Amendments to the Drawings:

REMARKS/ARGUMENTS

In response to the Examiner's first Office Action of December 23, 2005 the Applicant respectfully submits the accompanying Amendment to the specification, drawings and claims and the below Remarks.

FIG. 43

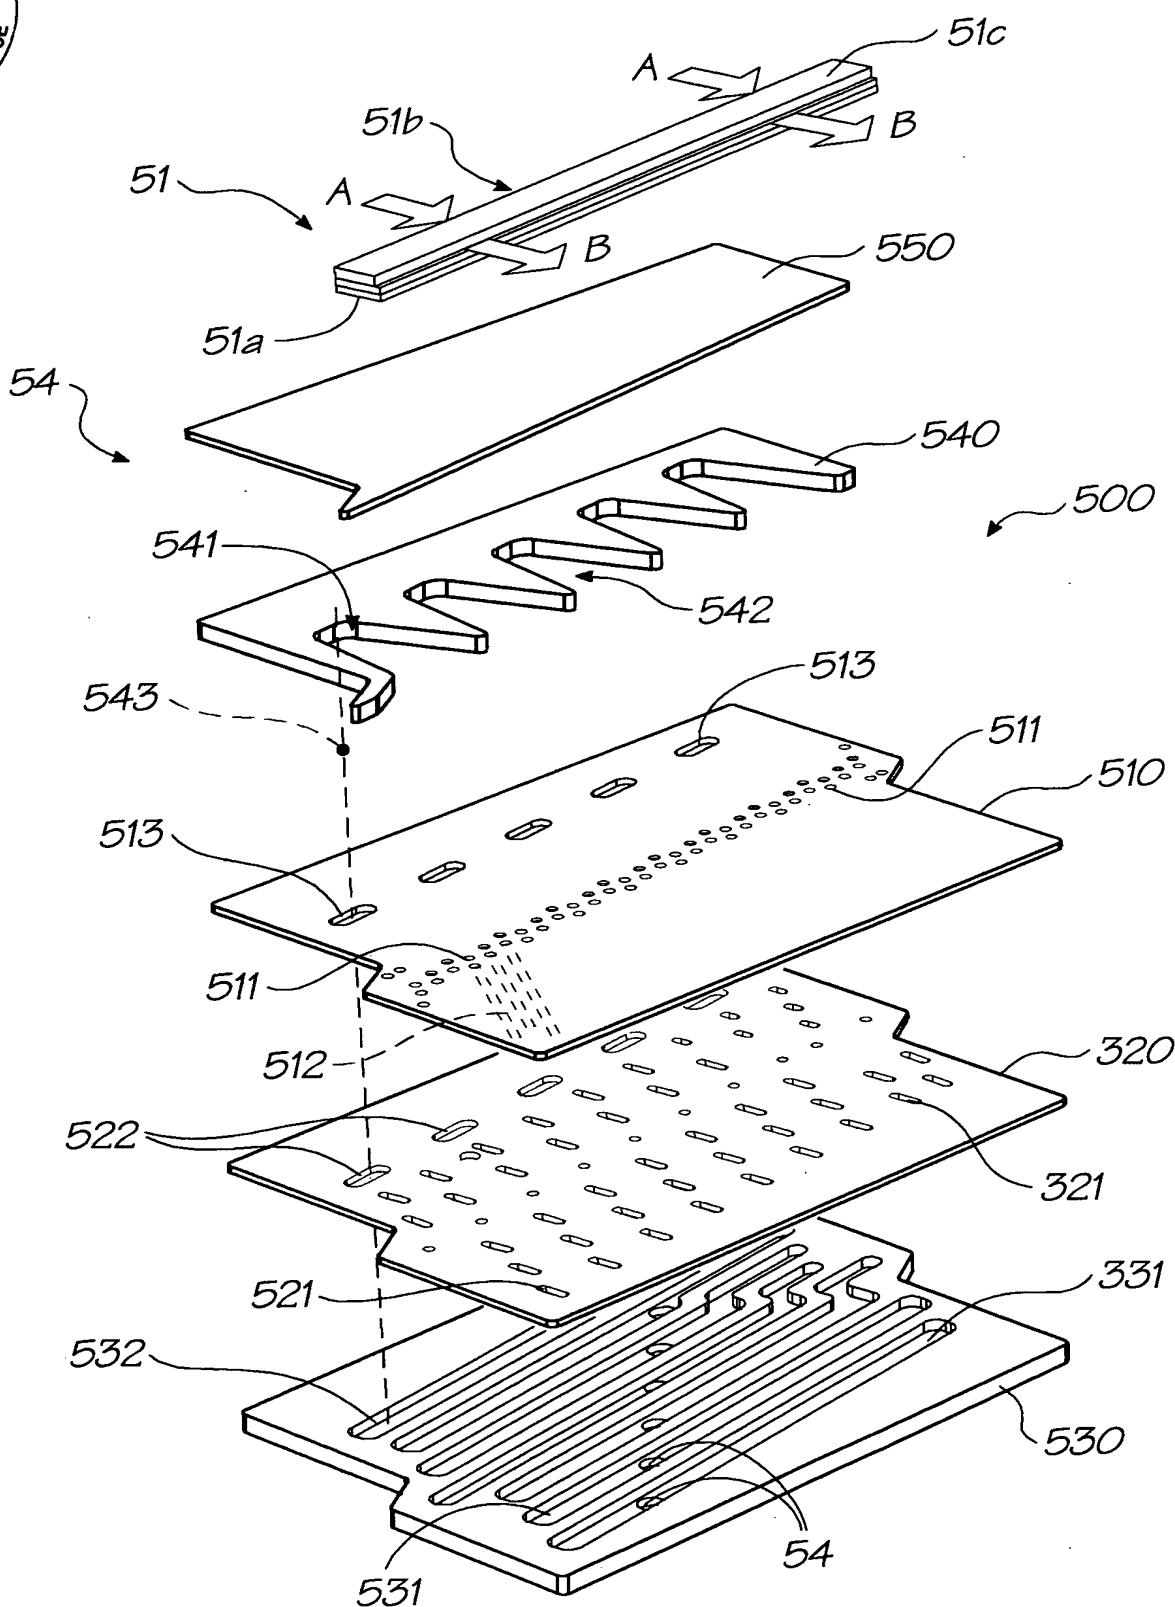
Fig. 43 is amended to include the reference sign "500", as is described at page 8, lines 13-21 of the present specification;

Regarding reference sign "500"

A corrected Fig. 43 is enclosed.

It is respectfully submitted that the above-described amendment to Fig. 43 to insert the reference sign "500", provides the correction required by the Examiner.
